Brooks County High School Field House HVAC upgrades.

ADDENDUM NO. 1

ADDENDUM NO. 1

DATE: July 02, 2025
Project: Falfurrias HS Fieldhouse HVAC Upgrades
Project #: 25v50
To: David Monreal, GMS

ME3.2

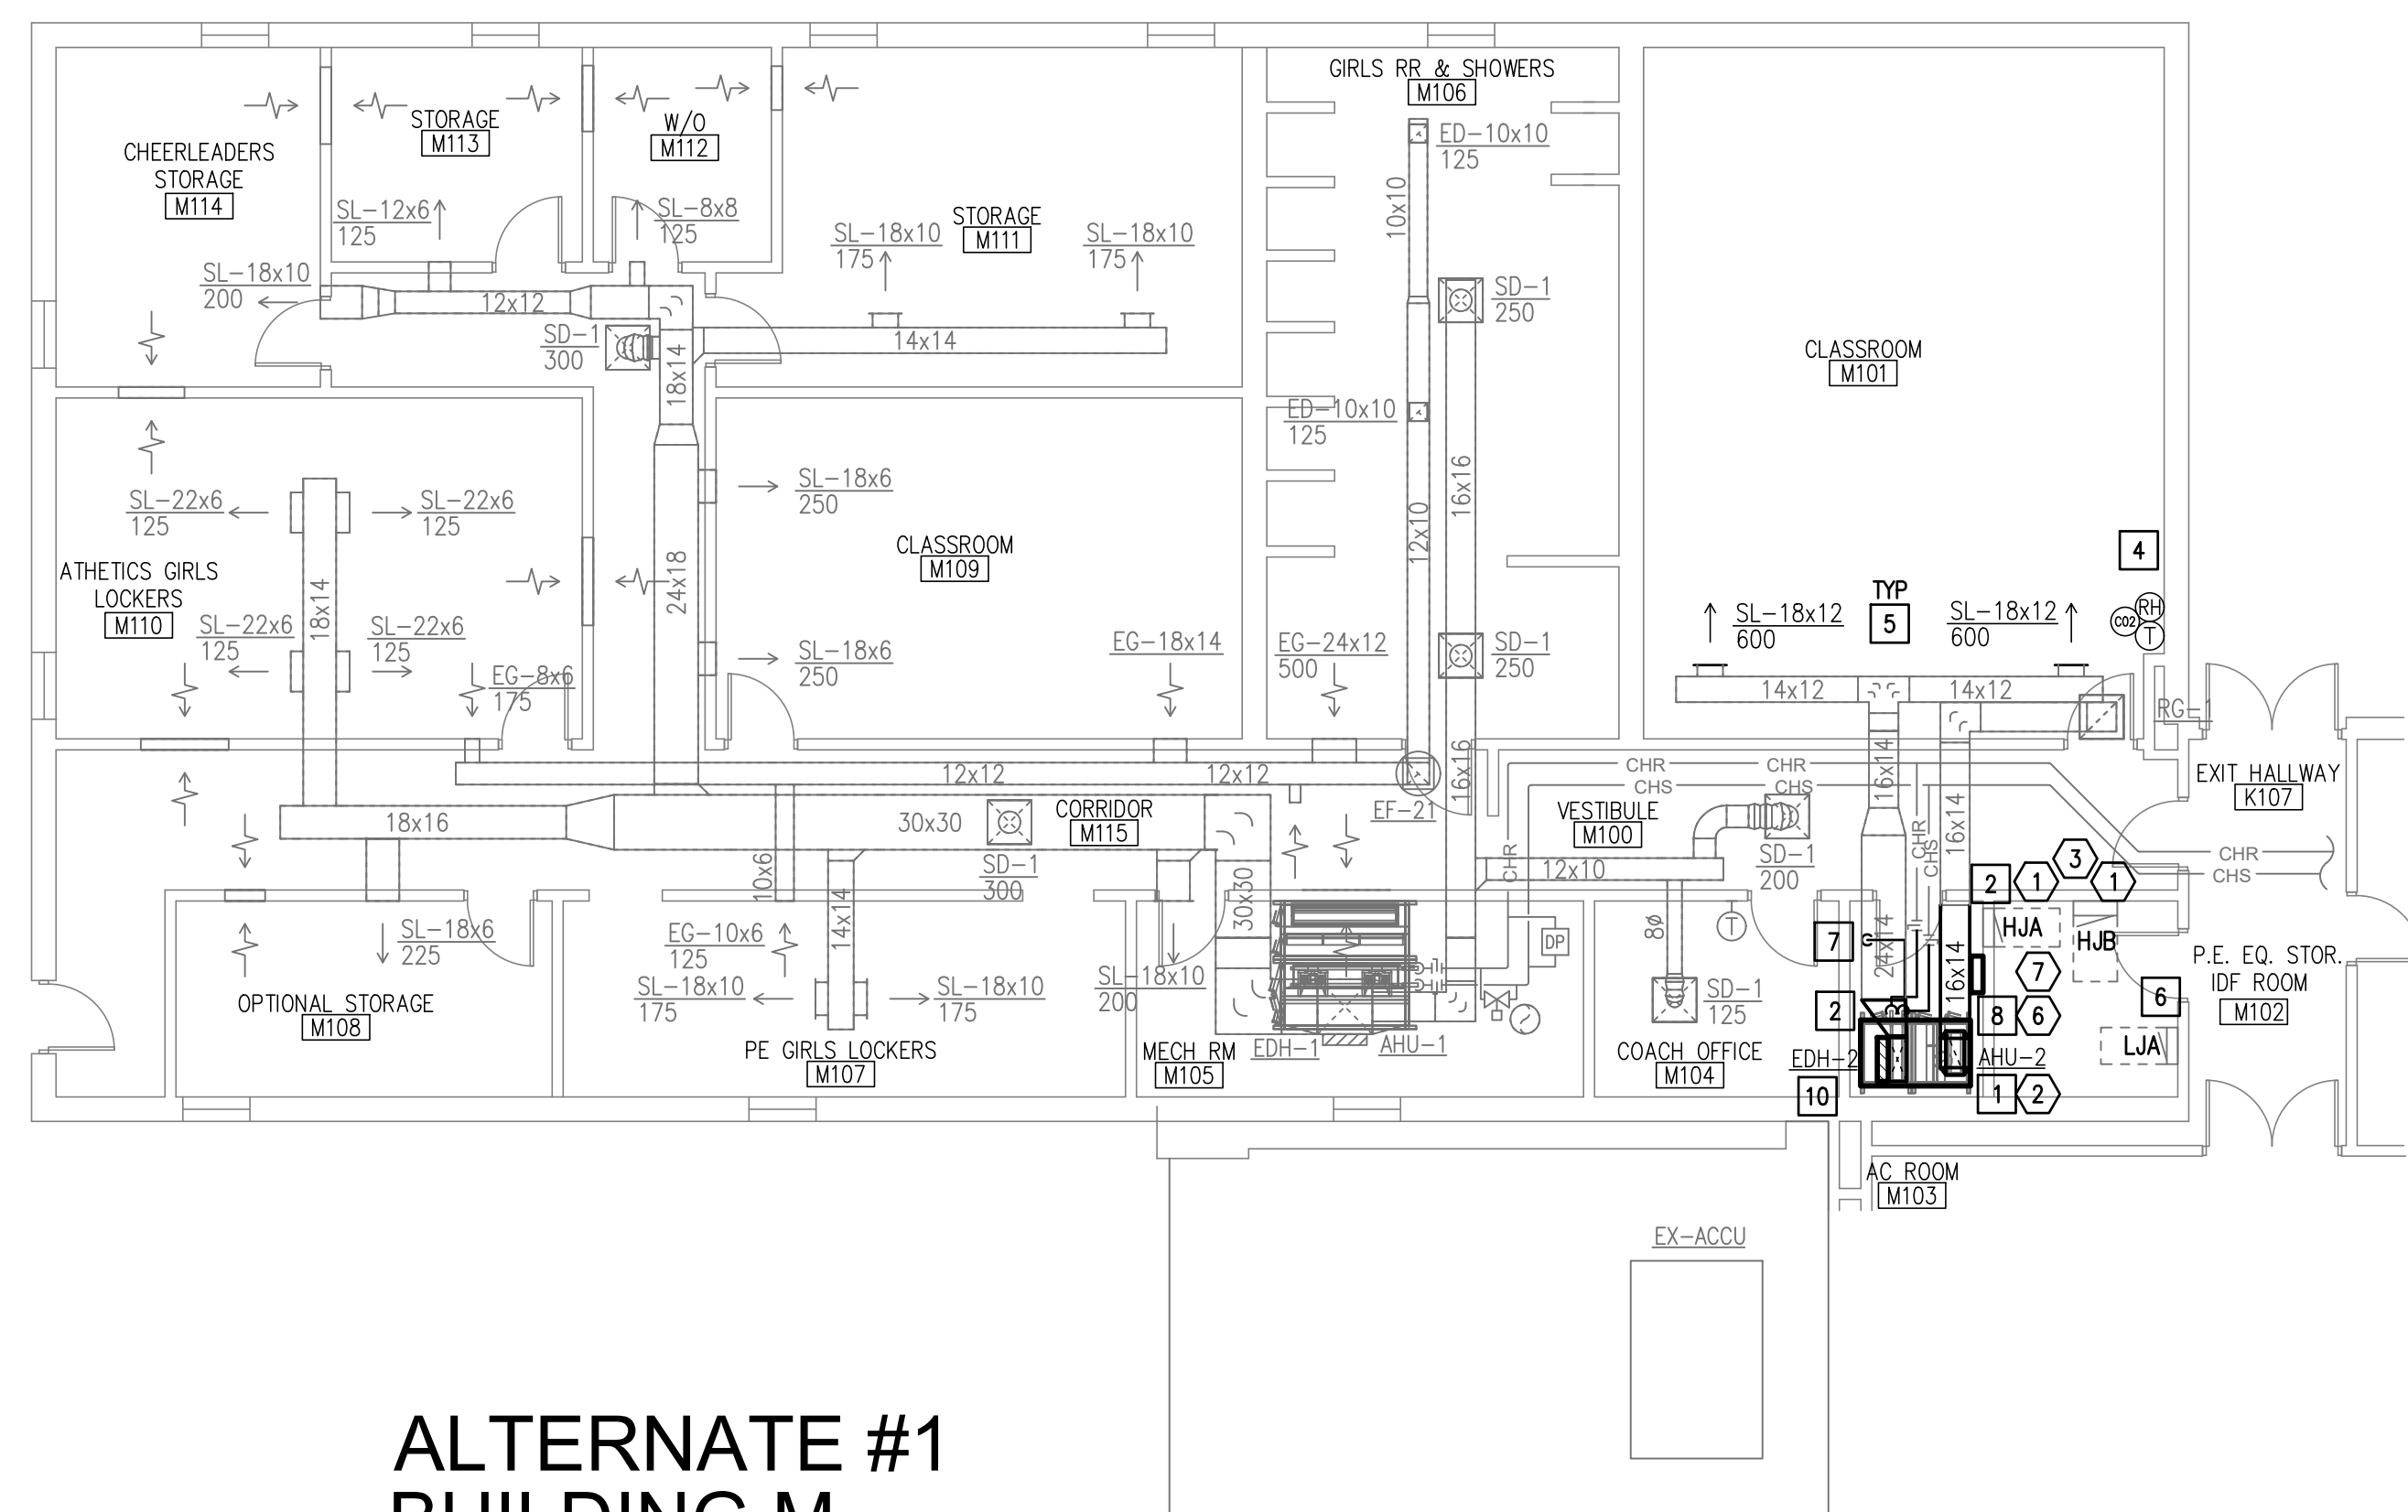
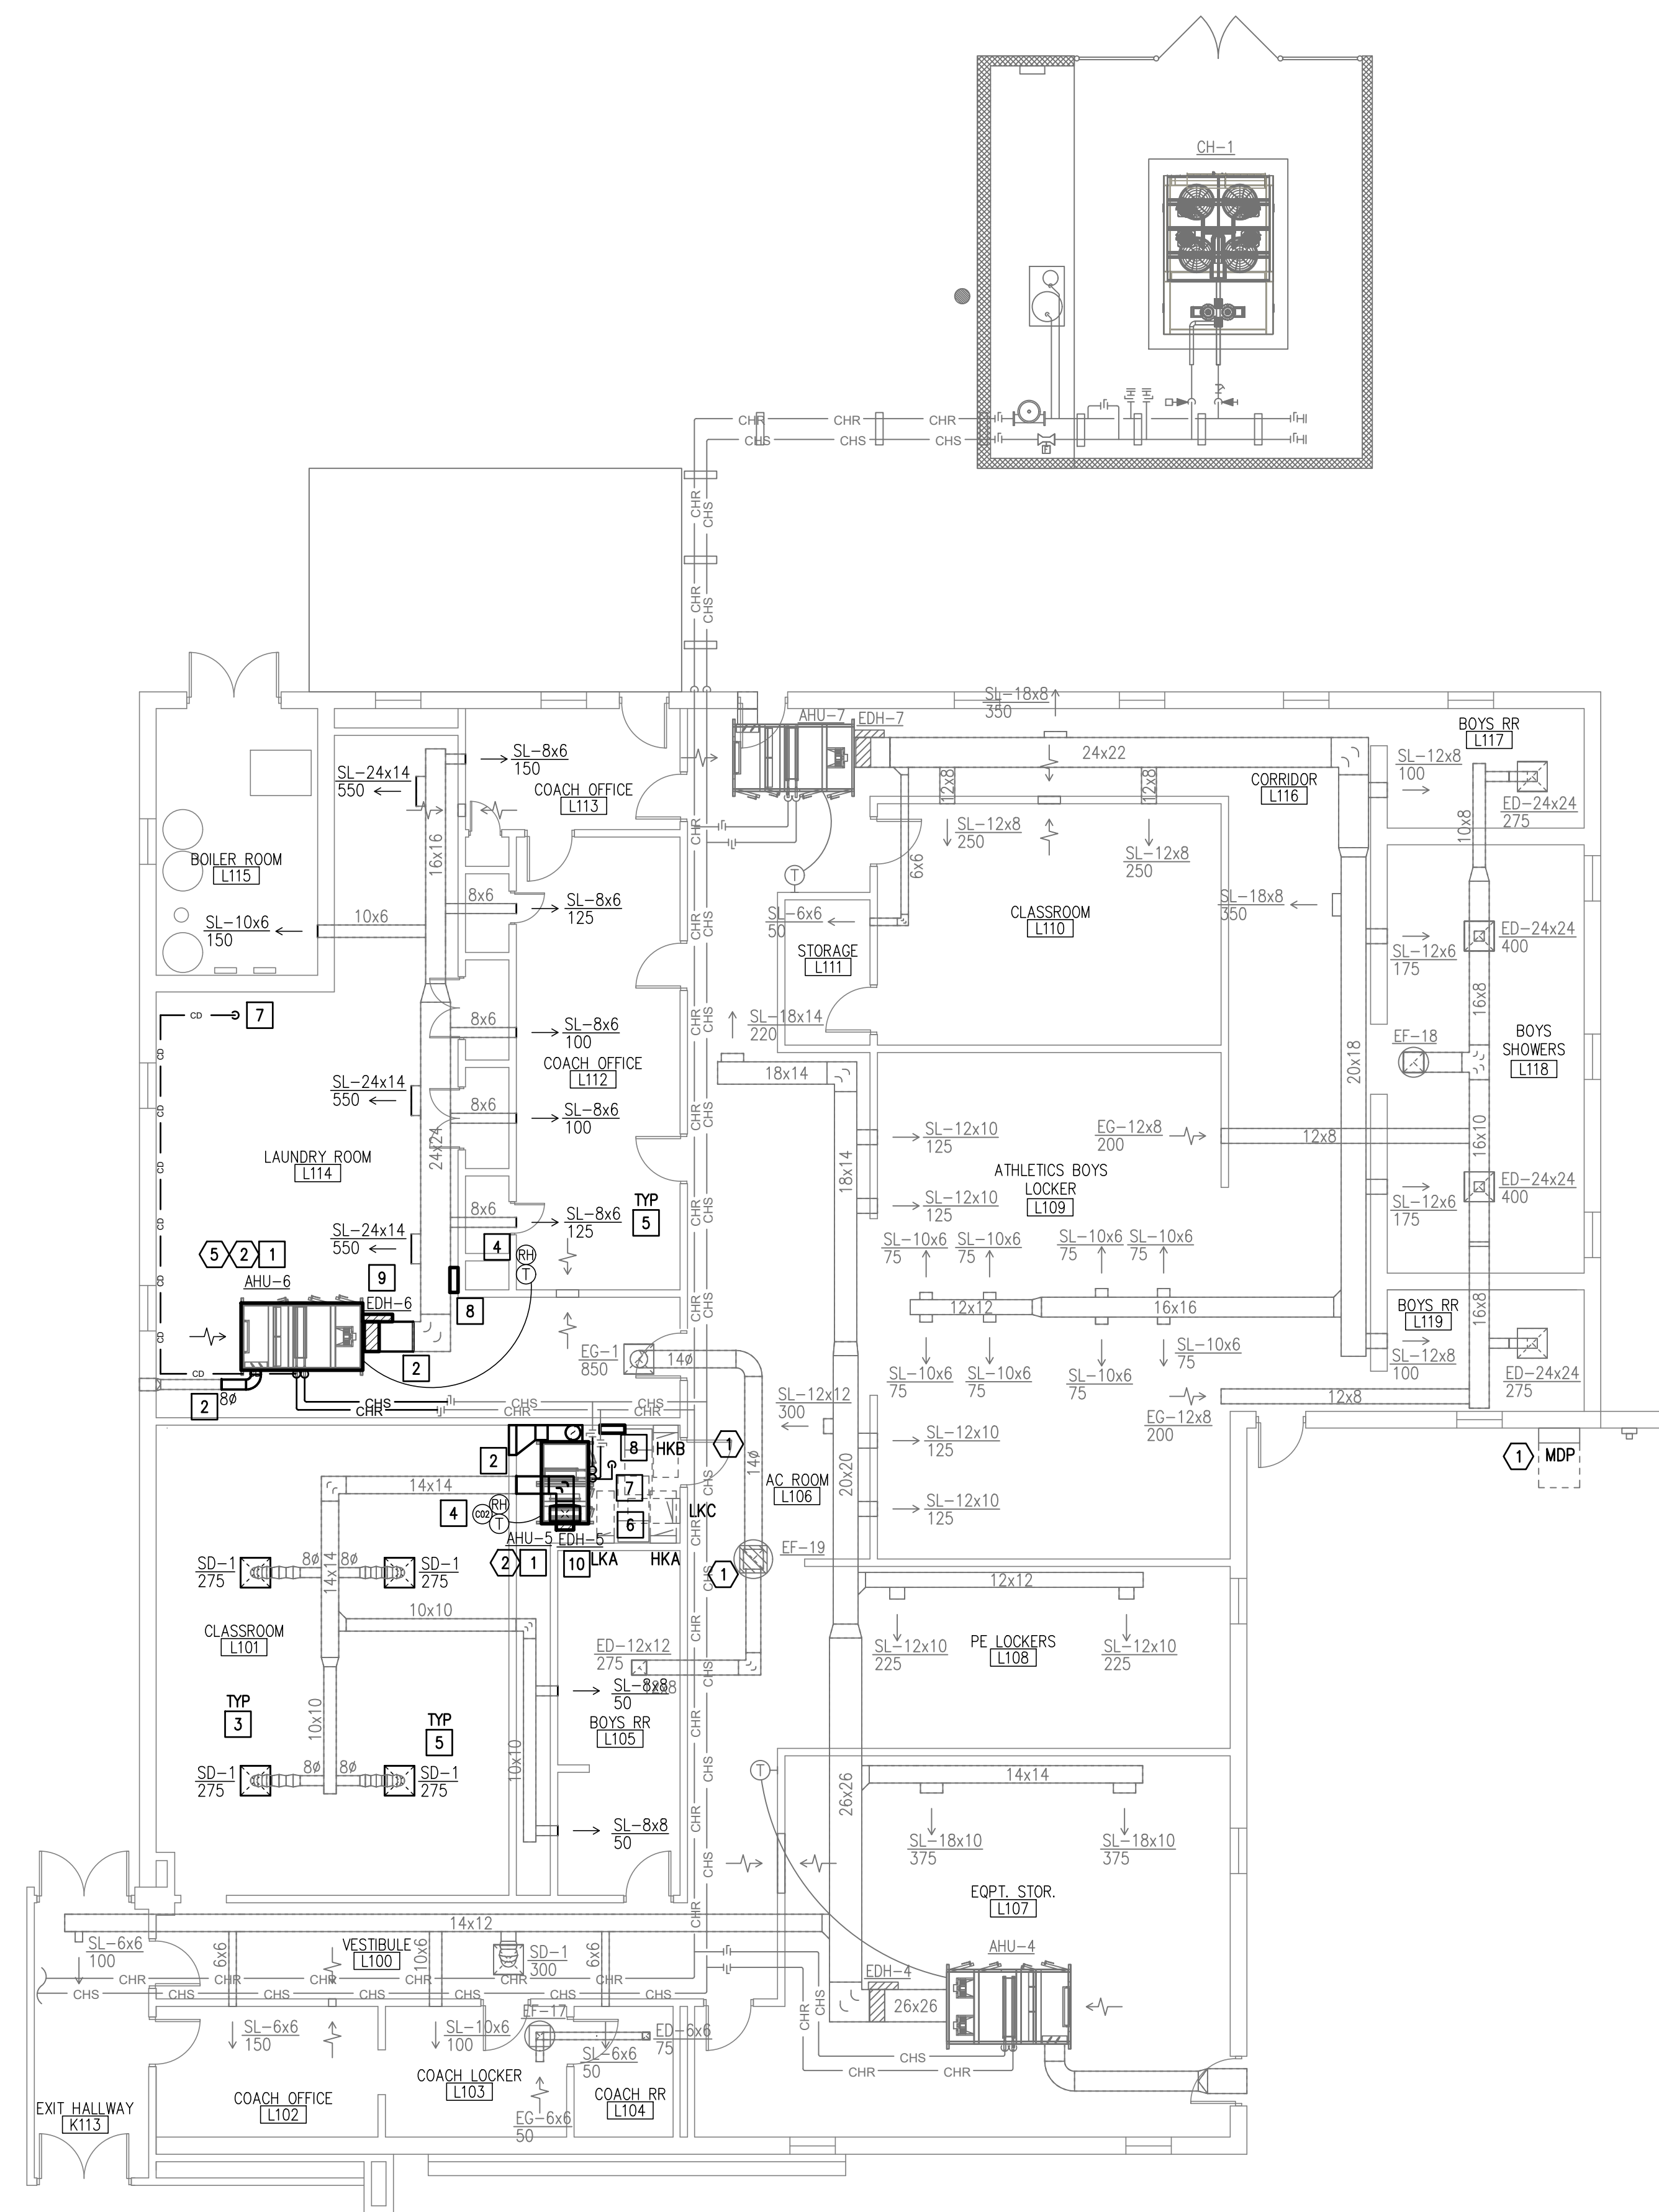
5. Sheet ME3.1:
 - a. Revised Building M and Building L Mechanical and Electrical renovation floor plan. See attached sheet.
6. Sheet ME3.2:
 - a. Revised Building M and Building L Mechanical and Electrical renovation floor plan. See attached sheet.
7. Sheet ME3.3:
 - a. Revised Building M and Building L Mechanical renovation roof plan. See attached sheet.
8. Sheet ME4.0:
 - a. Revised Building L, M and Central Plant Chilled Water Schematic Diagram. See attached sheet.
9. Sheet ME5.0:
 - a. Revised Mechanical and Electrical equipment and connection schedules. See attached sheet.
